Application No: A006662187

Property Address: 80 Barrett Street, Bracken Ridge QLD 4017

Proposal: Material Change of Use – Multiple Dwelling

Subject: Response to Council's Information Request – Traffic Matters

SITE PLAN 1 : 500

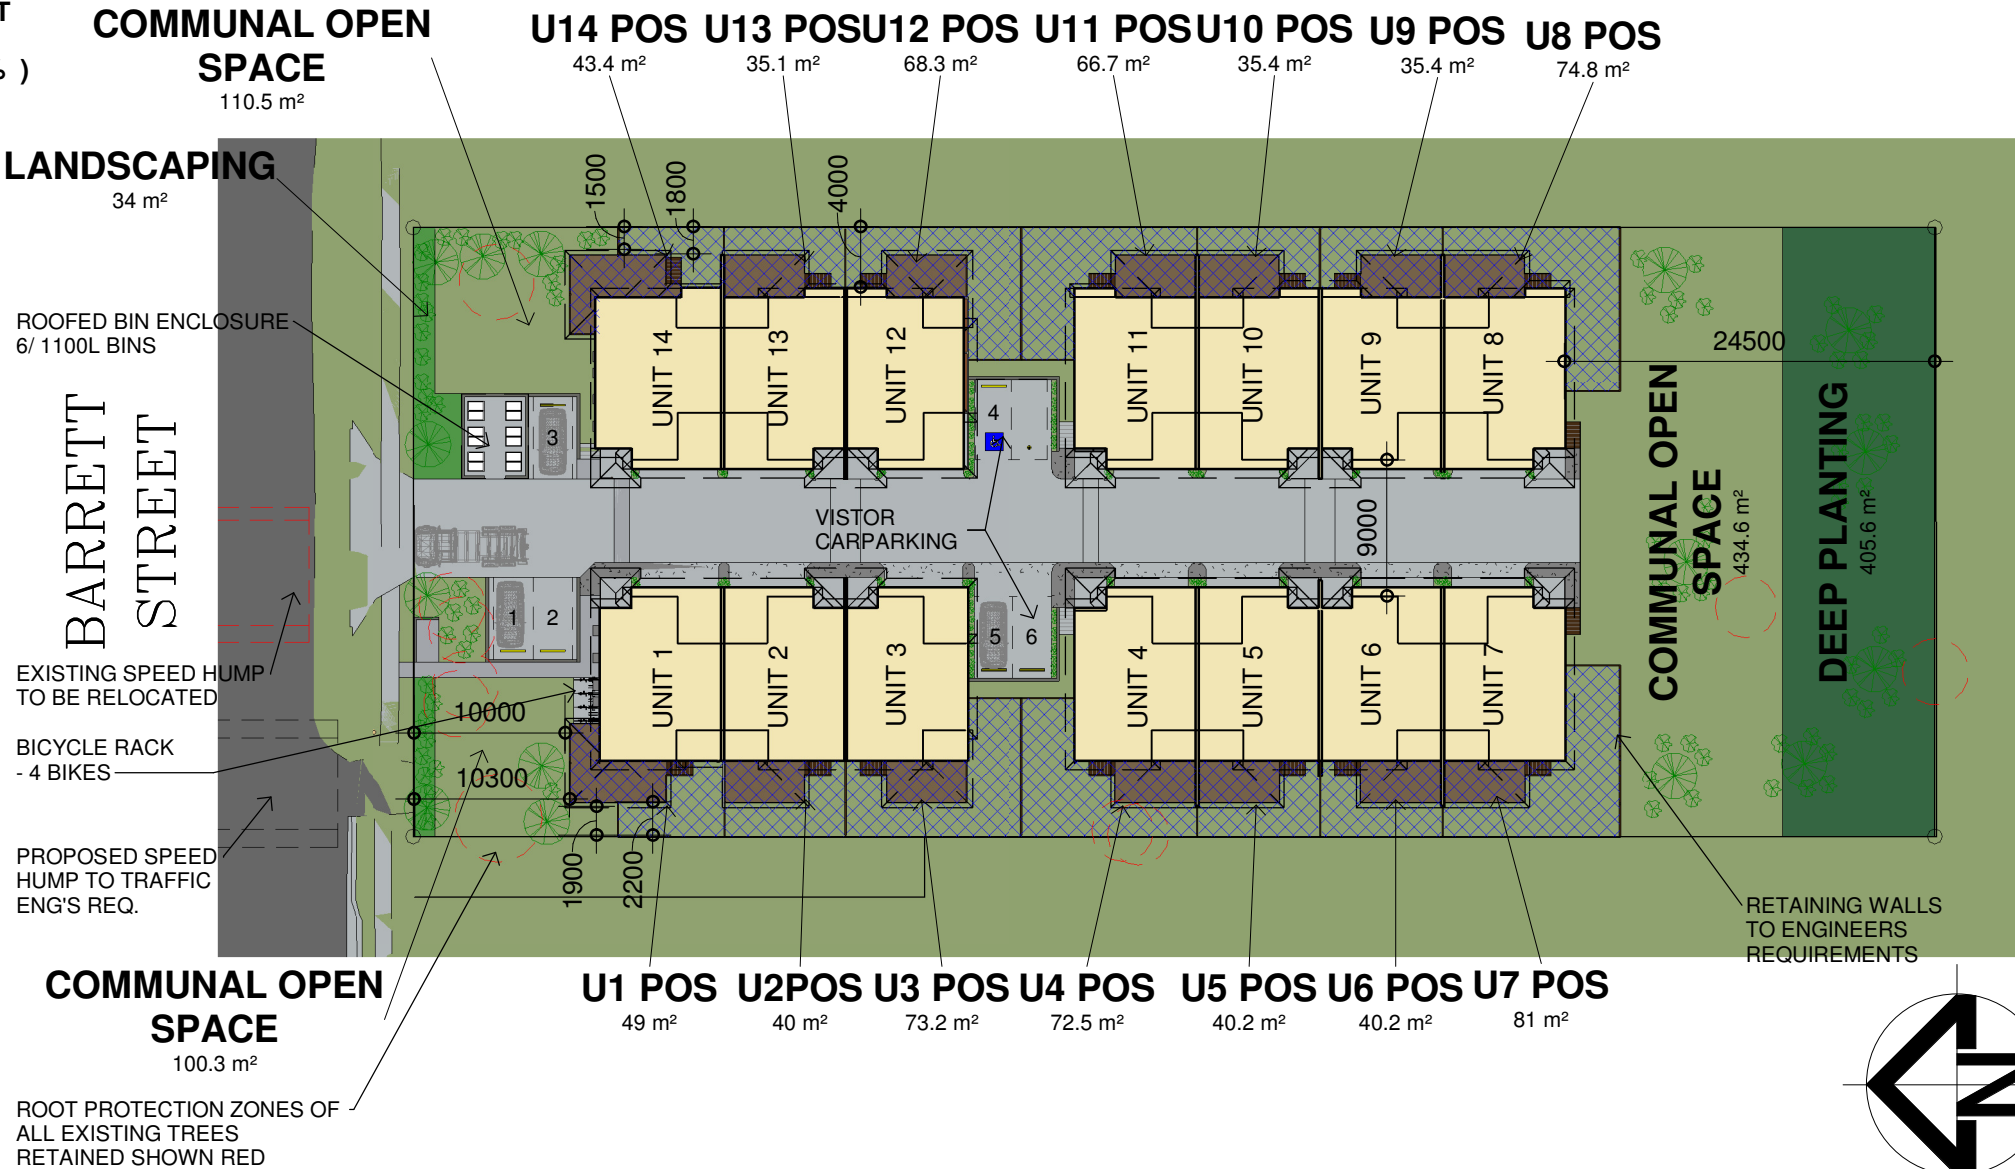
b) The amended design is to make provision for bicycle spaces for visitors (minimum 4 bicycles spaces) in common areas and also demonstrate a minimum of 1 resident bicycle space per unit.

b) Demonstrate a roofed and wholly screened refuse enclosure with minimum internal dimensions of 8.6m x 1.5m (12.9m²) to accommodate bulk bins. Ensure the dimensions are included on the amended plans.

13. The site layout does not demonstrate an appropriate prioritized pedestrian pathway from the street to the individual units. Provide amended plans incorporating a pathway demarcation to address the concerns of the shared pedestrian / vehicle driveway. This pedestrian pathway is to be of a different material and finish annotated on the drawings that is adjacent to the ground floor entrances to each townhouse (painting is not acceptable).

As shown in the amended development plans included as **Attachment 1**, provision is made for four (4) visitor bicycle parking spaces to the north of Unit 1.

As shown in the amended development plans included as **Attachment 1**, a refuse enclosure is proposed adjacent to the entry side of the driveway. This enclosure has internal dimensions of 4.0m x 5.2m (i.e. 20.8m²), and should be adequate to accommodate 6 x 1100L bulk bins.

As shown in the amended development plans included as **Attachment 1**, a pedestrian pathway is proposed connecting to the site frontage, extending along the western side of visitor parking spaces 1 and 2, and into the driveway area. A delineated footpath will extend along the eastern face of the western units within the parking aisle, with parking aisle crossing points also delineated.

Diagram – Relocated Speed Hump

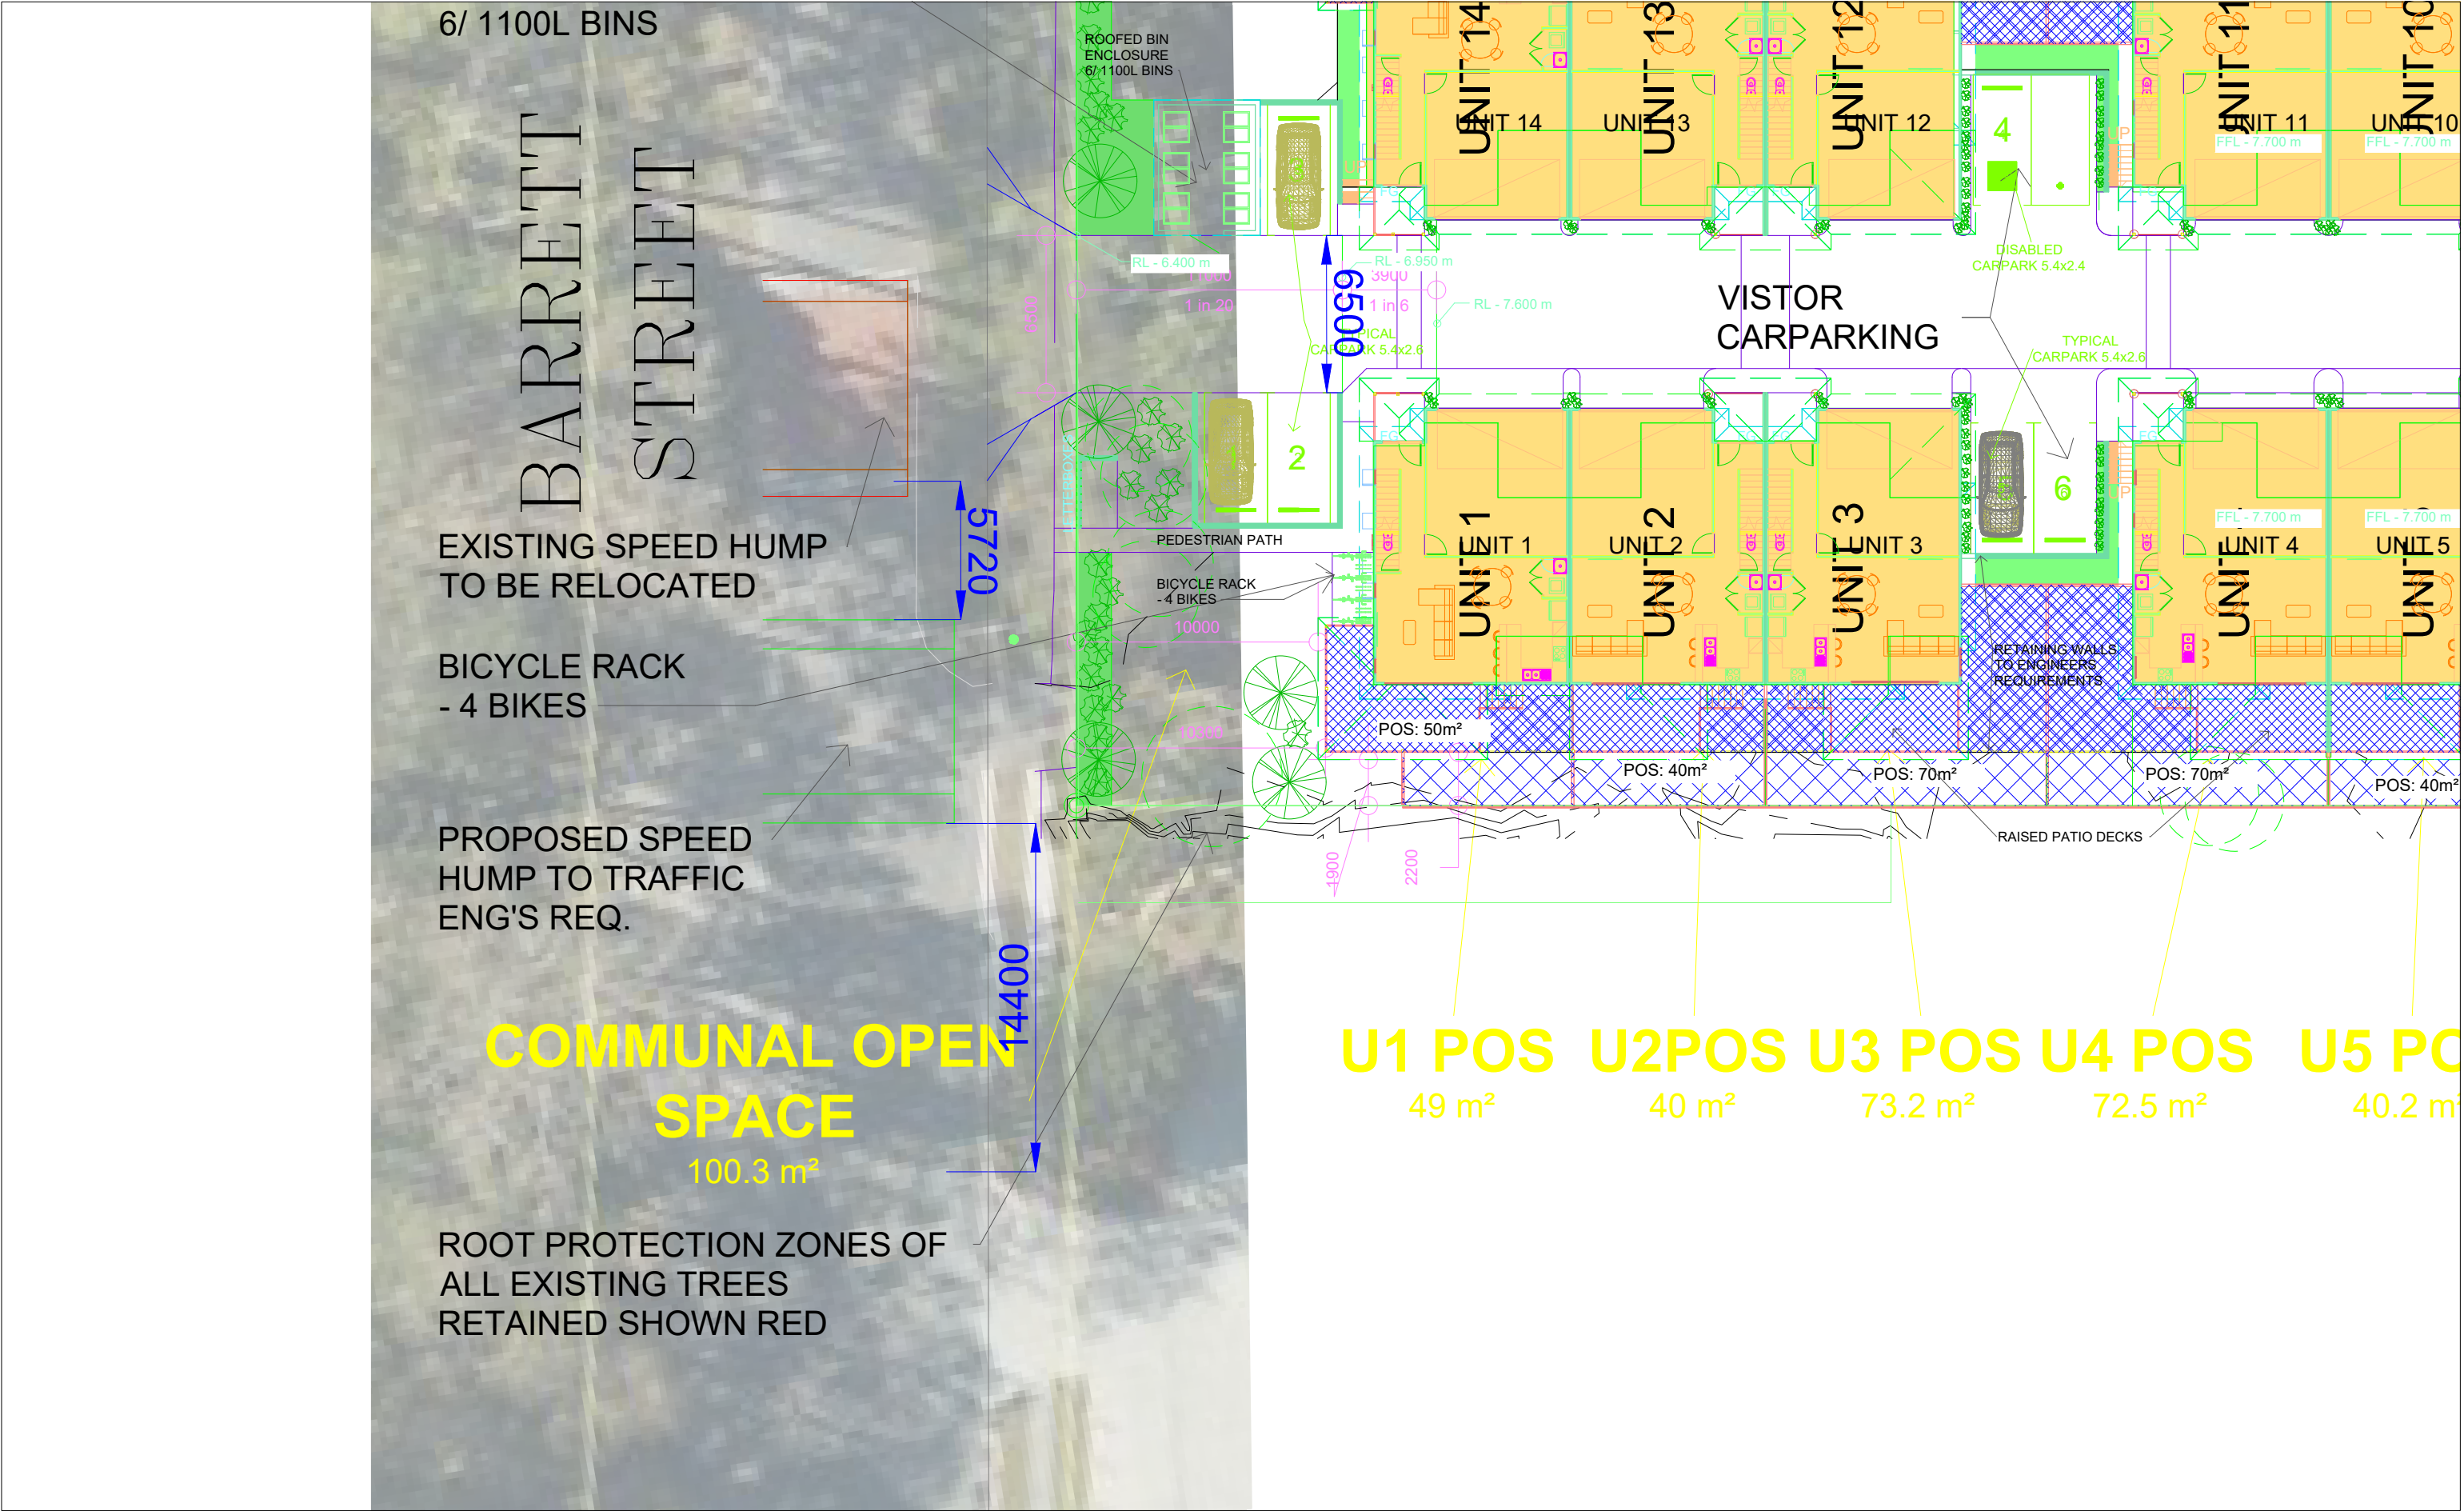
8. The proposed location and type of the access crossover requires review as it conflicts with the existing traffic control device (speed restriction device) at the frontage of the site. Access to the development is not supported through the traffic control device.

a) The location of the access crossover to the site, width and type needs to be reviewed by an RPEQ engineer and repositioned to provide for an optimal access location, without conflicting and/or impacting existing traffic devices or any other road infrastructure or creating an adverse impact on the road.

Accordingly, it is proposed that the speed hump on Barrett Street be relocated approximately 14m to the west, clear of the proposed access driveway location. This could be undertaken as part of the frontage works to be completed on Barrett Street (i.e. widening of the road, kerb and channel and footpath).

As shown in the diagram included as **Attachment 2**, in the proposed location, there would be approximately 14.4m separation from the relocated speed hump to the existing access driveway to the childcare centre on the site to the west, and approximately 5.7m separation from the relocated speed hump to the proposed access driveway to the east. These separation distances are considered to be adequate, and not in contravention of any requirement in Council's Transport, Access, Parking and Servicing (TAPS) Planning Scheme Policy.

Importantly, in the proposed location, the speed hump on Barrett Street will continue to slow traffic approaching the childcare centre and on the local street more generally, as intended.

Vehicle Tracking Diagram – Service Vehicles

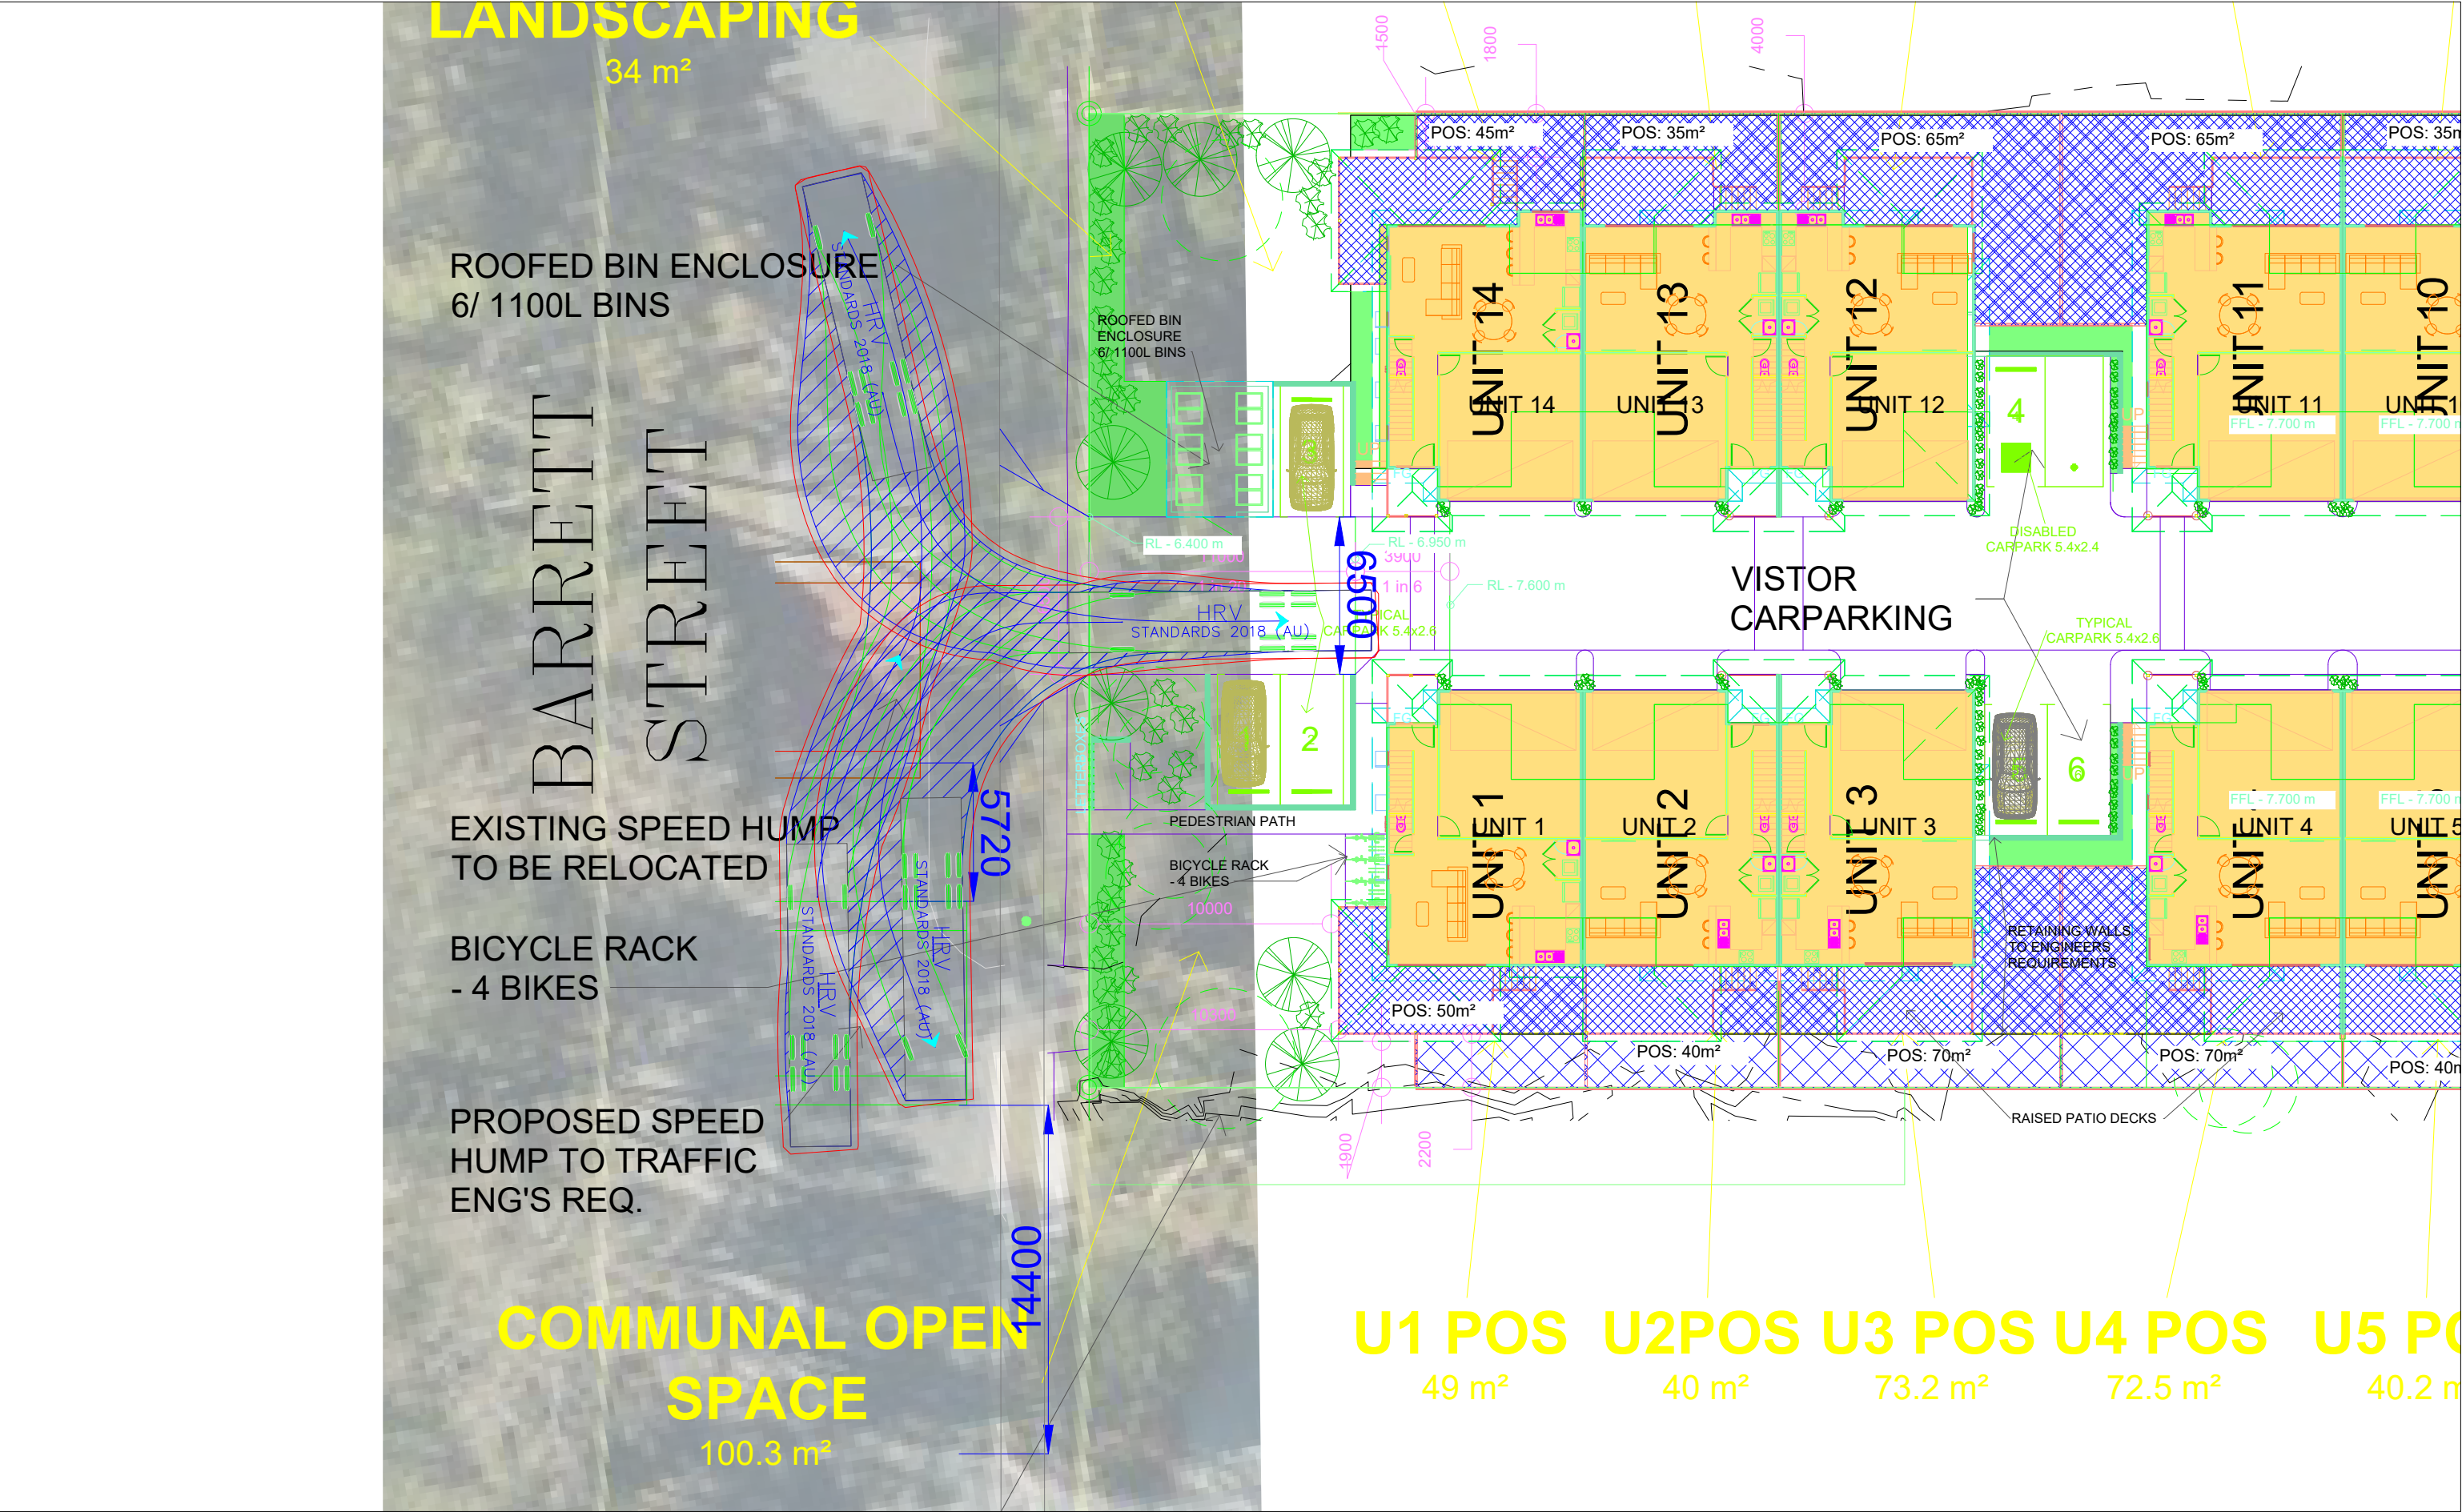
b) The access crossover and driveway needs to cater for service vehicles being an LRV (occasional access) for furniture removalist and RCV for regular access for refuse bin collection (refer to refuse item below). If proposing a performance solution, it must be supported by an RPEQ prepared traffic statement.

9. Provide RPEQ endorsed swept path manoeuvring drawings for the following design vehicles; being an LRV and RCV (as specified in BSD 3008-2) demonstrating that safe and efficient service is achieved within the site.

a) Demonstrate a minimum 6.5m wide Type B2 crossover and minimum 6.5m wide internal aisle where trafficked by the Refuse Collection Vehicle (RCV). Ensure the minimum 6.5m wide clearance also includes the upper levels of the townhouses and any other built form.

As shown in the vehicle tracking diagrams included as **Attachment 3**, a 12.5m long Heavy Rigid Vehicle and a 10.24m long rear-load refuse collection vehicle would be able to reverse onto the site for loading/unloading within the driveway area, before exiting the site in a forward direction. This is acceptable under Section 3.2 of Council's TAPS Planning Scheme Policy for occasional access, as well as regular access from a minor road.

It is recommended that a 6.5m wide driveway with Type B2 splays be provided (as shown in the diagrams included as **Attachment 3**), and this requirement could reasonably be included as a condition of the approval.

As shown in the vehicle tracking diagrams included as **Attachment 3**, it is proposed that service vehicles use the section of driveway immediately inside the frontage boundary, prior to the units. This section of driveway has a gradient of 1:20 which is satisfactory for refuse collection under the provisions of Council's Refuse Planning Scheme Policy. Importantly, this section of driveway is open to the sky above, and is 6.5m wide in accordance with Council's requirements to accommodate a refuse collection vehicle.

It is proposed that refuse collection vehicles use the section of aisle inside the property boundary, prior to the units. This section of driveway has a gradient of 1:20, which is satisfactory for refuse collection. Importantly, this section of driveway is open to the sky above, and is 6.5m wide in accordance with Council's requirements to accommodate a refuse collection vehicle.
